EDINBURG CISD

ADDENDUM 3
CSP 23-02
UTRGV-EDINBURG CISD COLLEGIATE HIGH SCHOOL
October 3, 2022

This addendum is issued for the purpose of modifying the plans and specifications for the *UTRG/EDINBURG CISD COLLEGIATE HIGH SCHOOL*.

01 ELECTRICAL RISER DIAGRAM
 SCALE: NONE

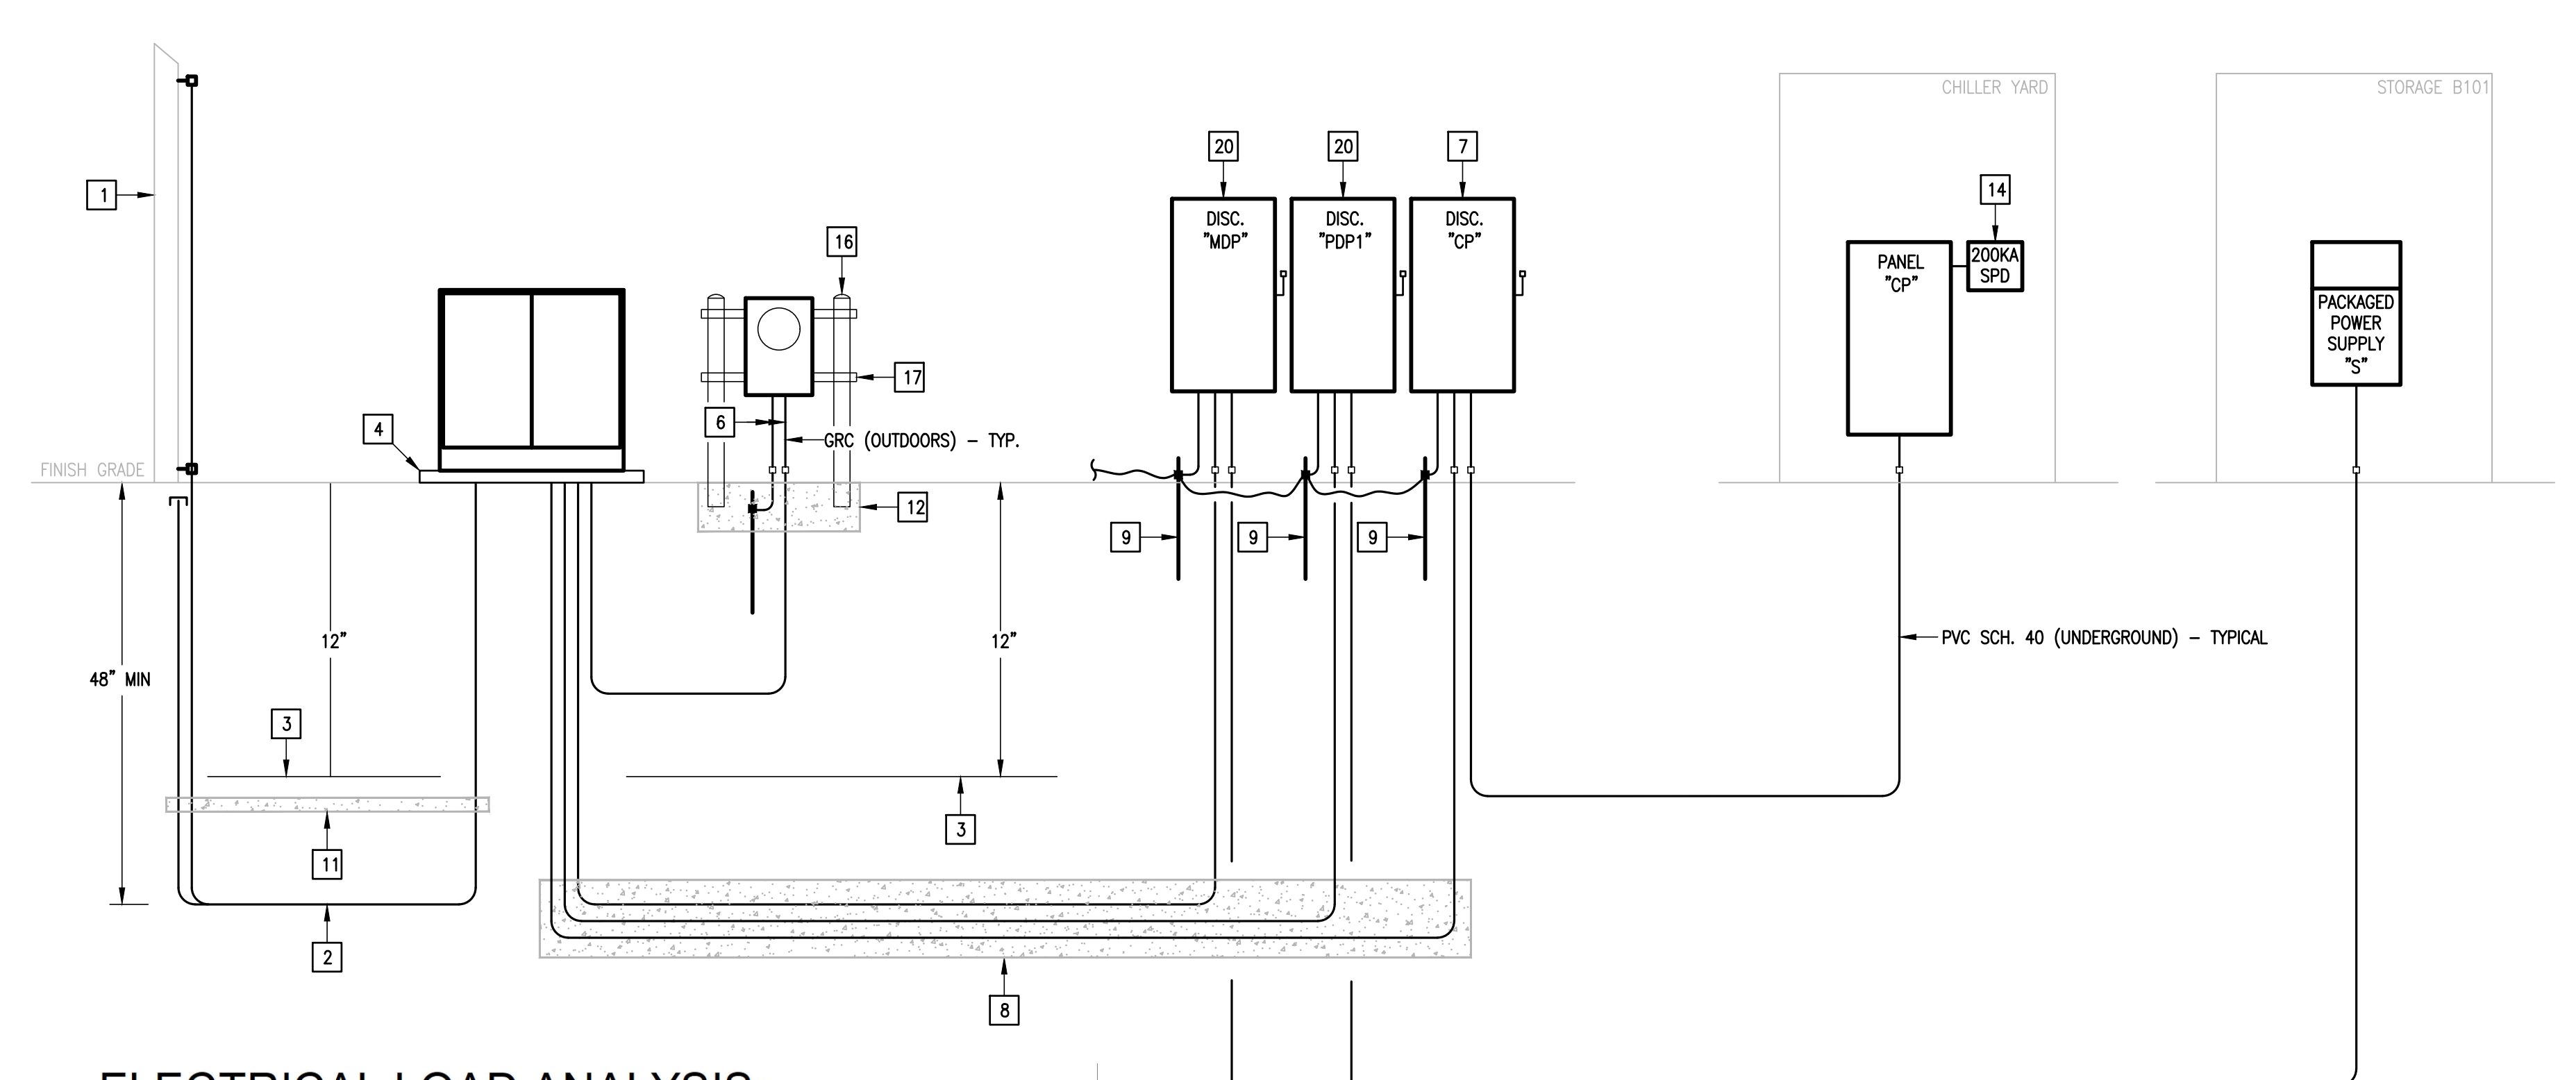
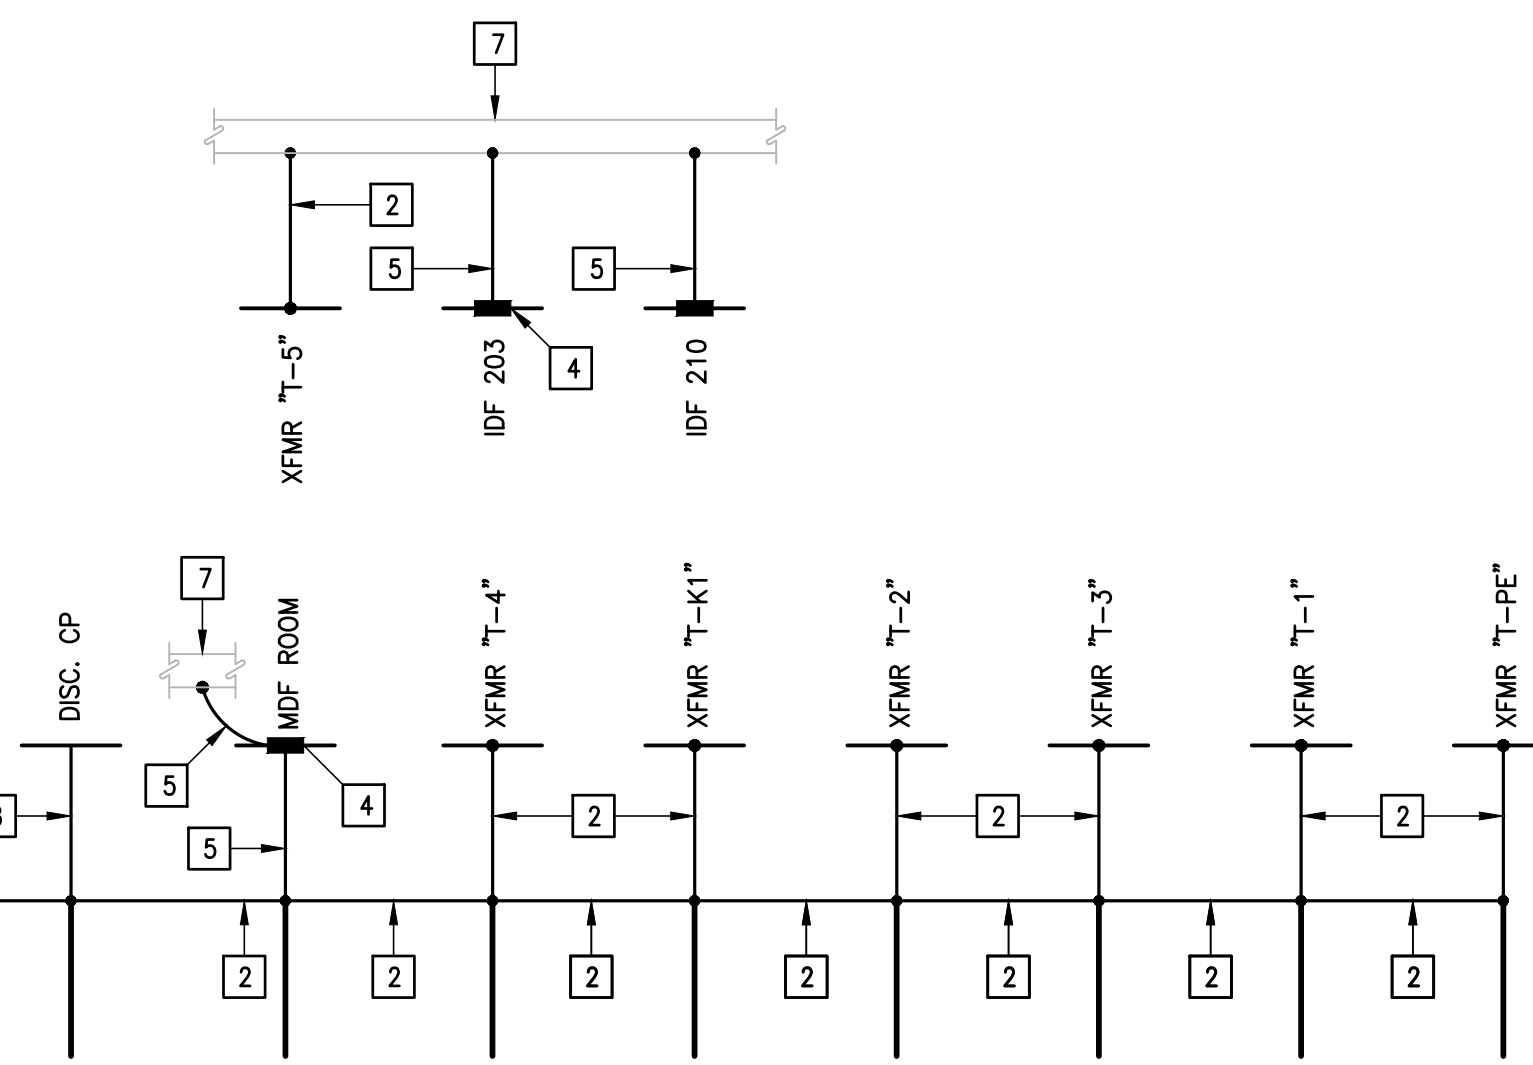
14. Sheet E7.01:
- a) Revised electrical riser diagram and feeder schedule. See attached sheet.
15. Sheet E8.01:
- a) Panel "MK": Provide Taylor Phase Guard/Time Mark protection and shunt-trip breaker for AHU-7.

02 SLIDE GATE OPERATOR DETAIL
SCALE: NOT TO SCALE

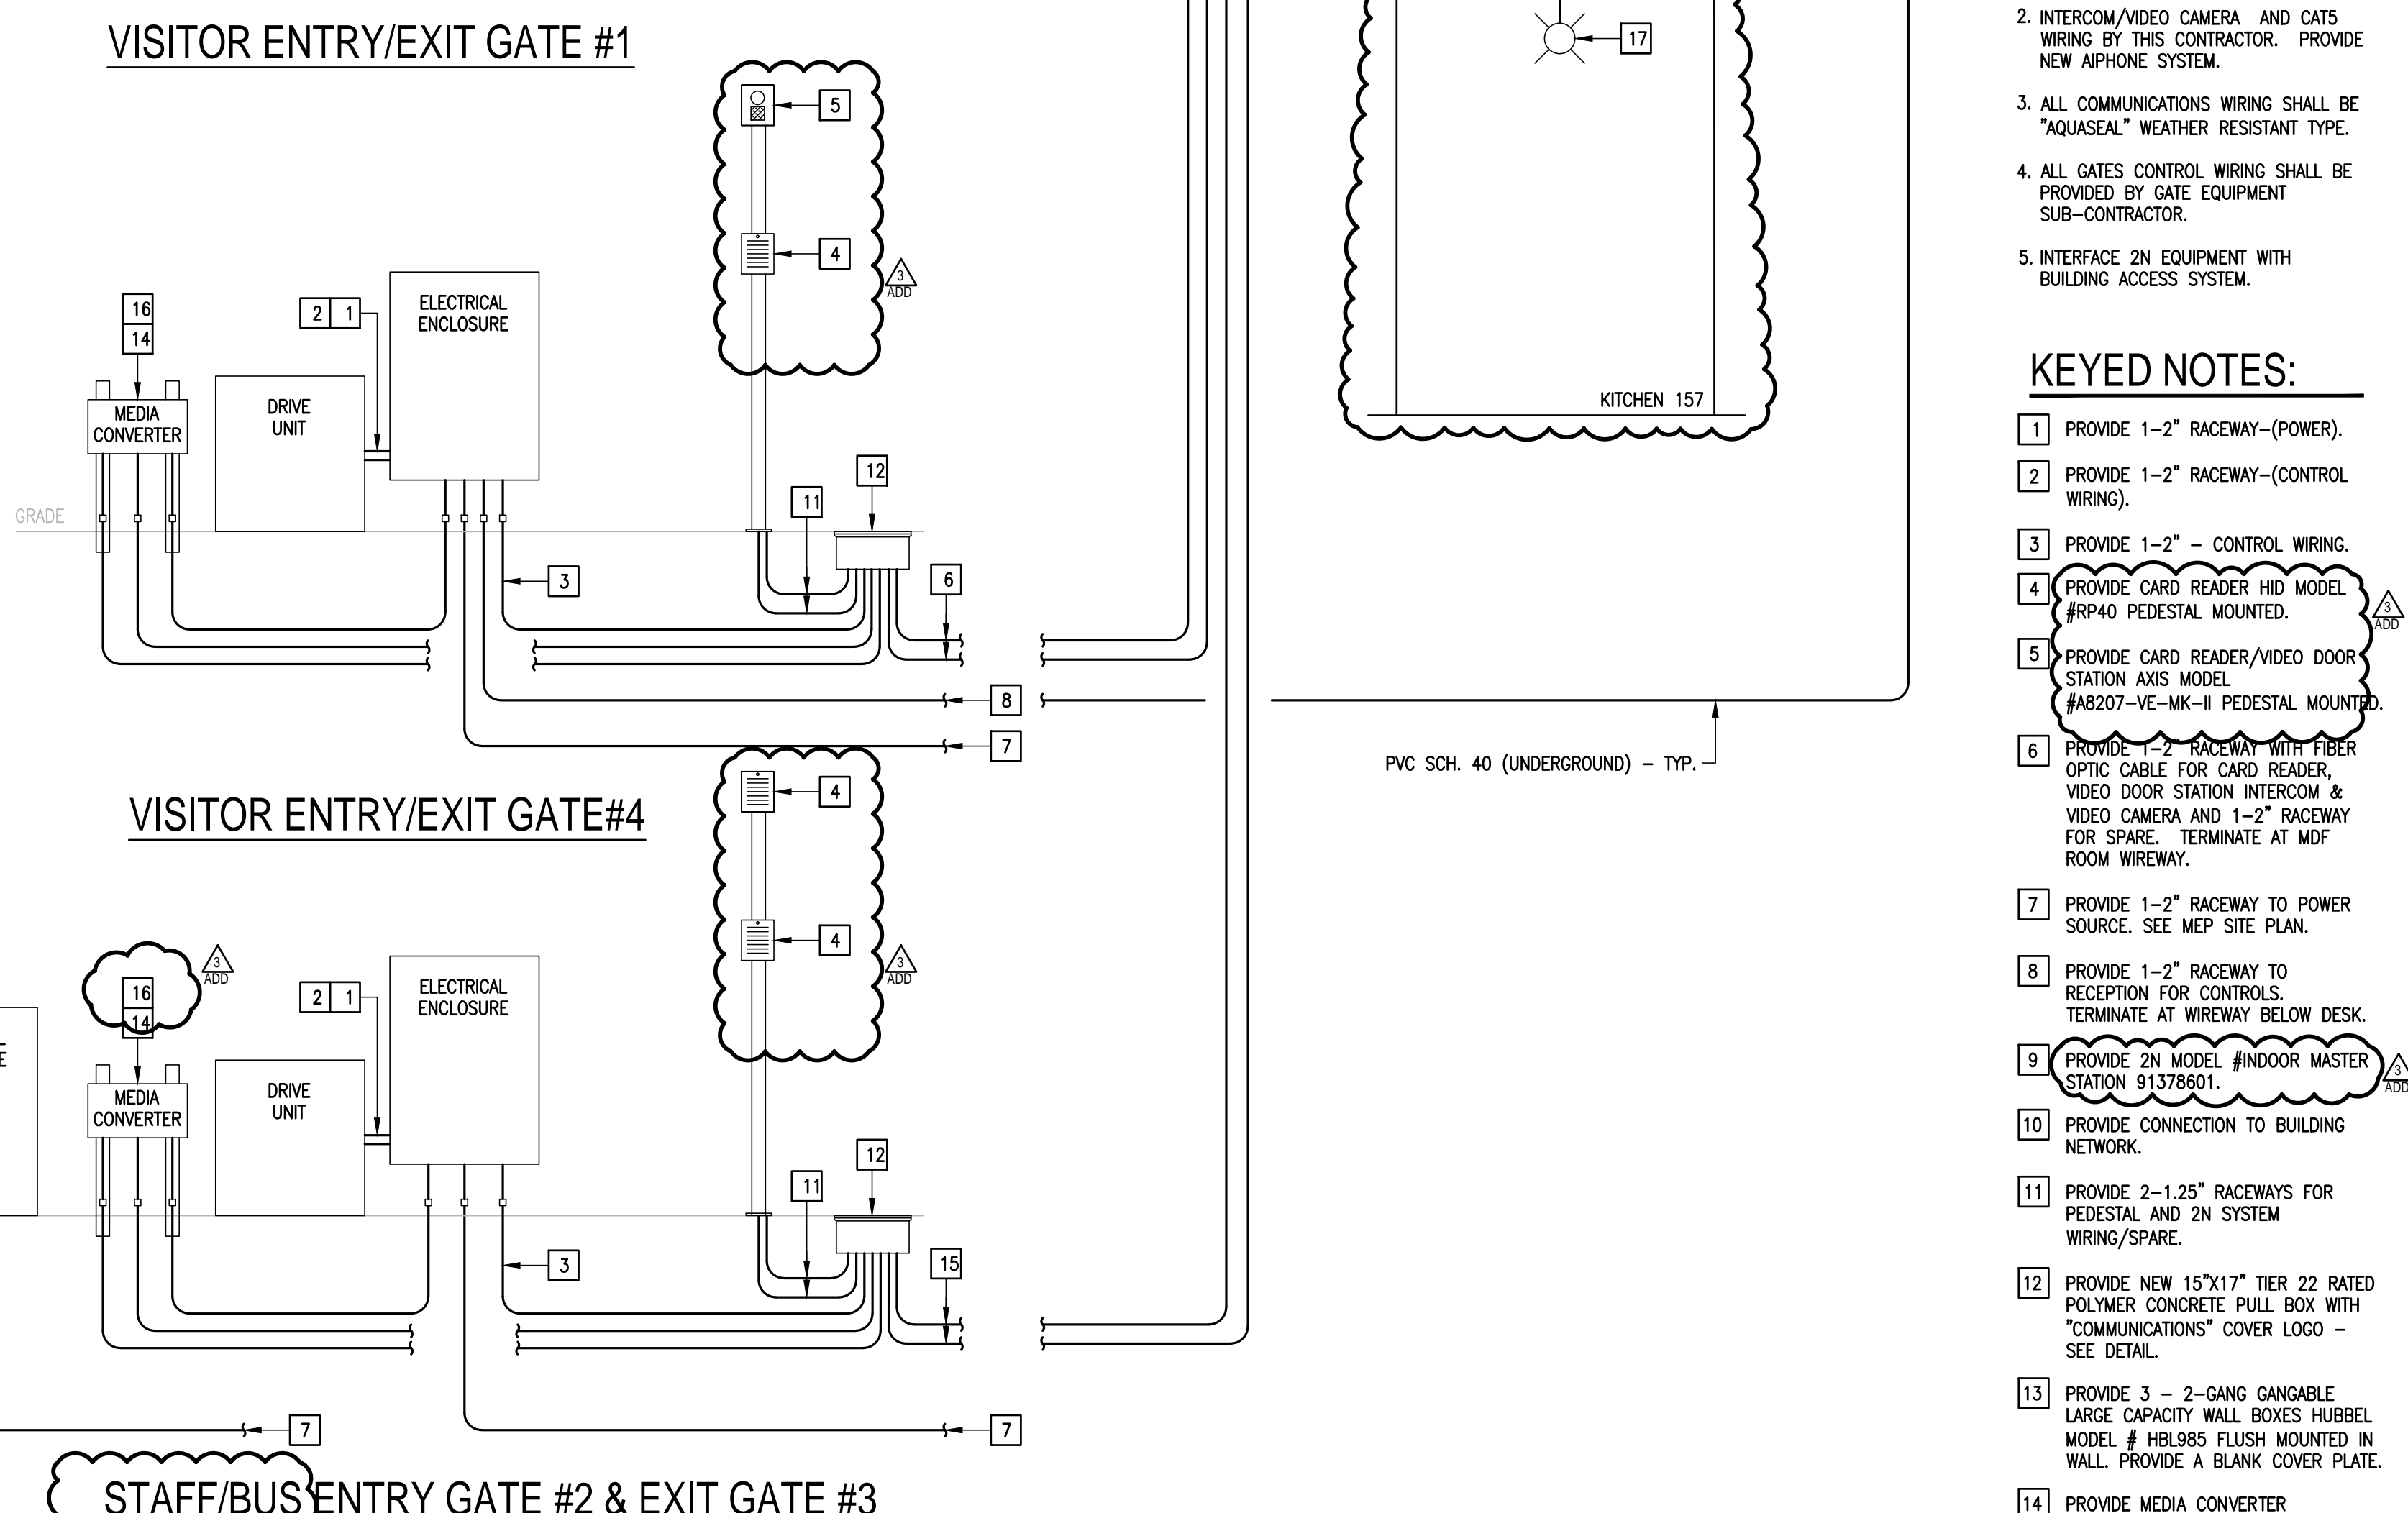
16. Sheet E8.02:
- a) Revised panel schedules. See attached sheet.
17. Sheet E9.03:
- a) Revised slide gate operator detail. See attached sheet.
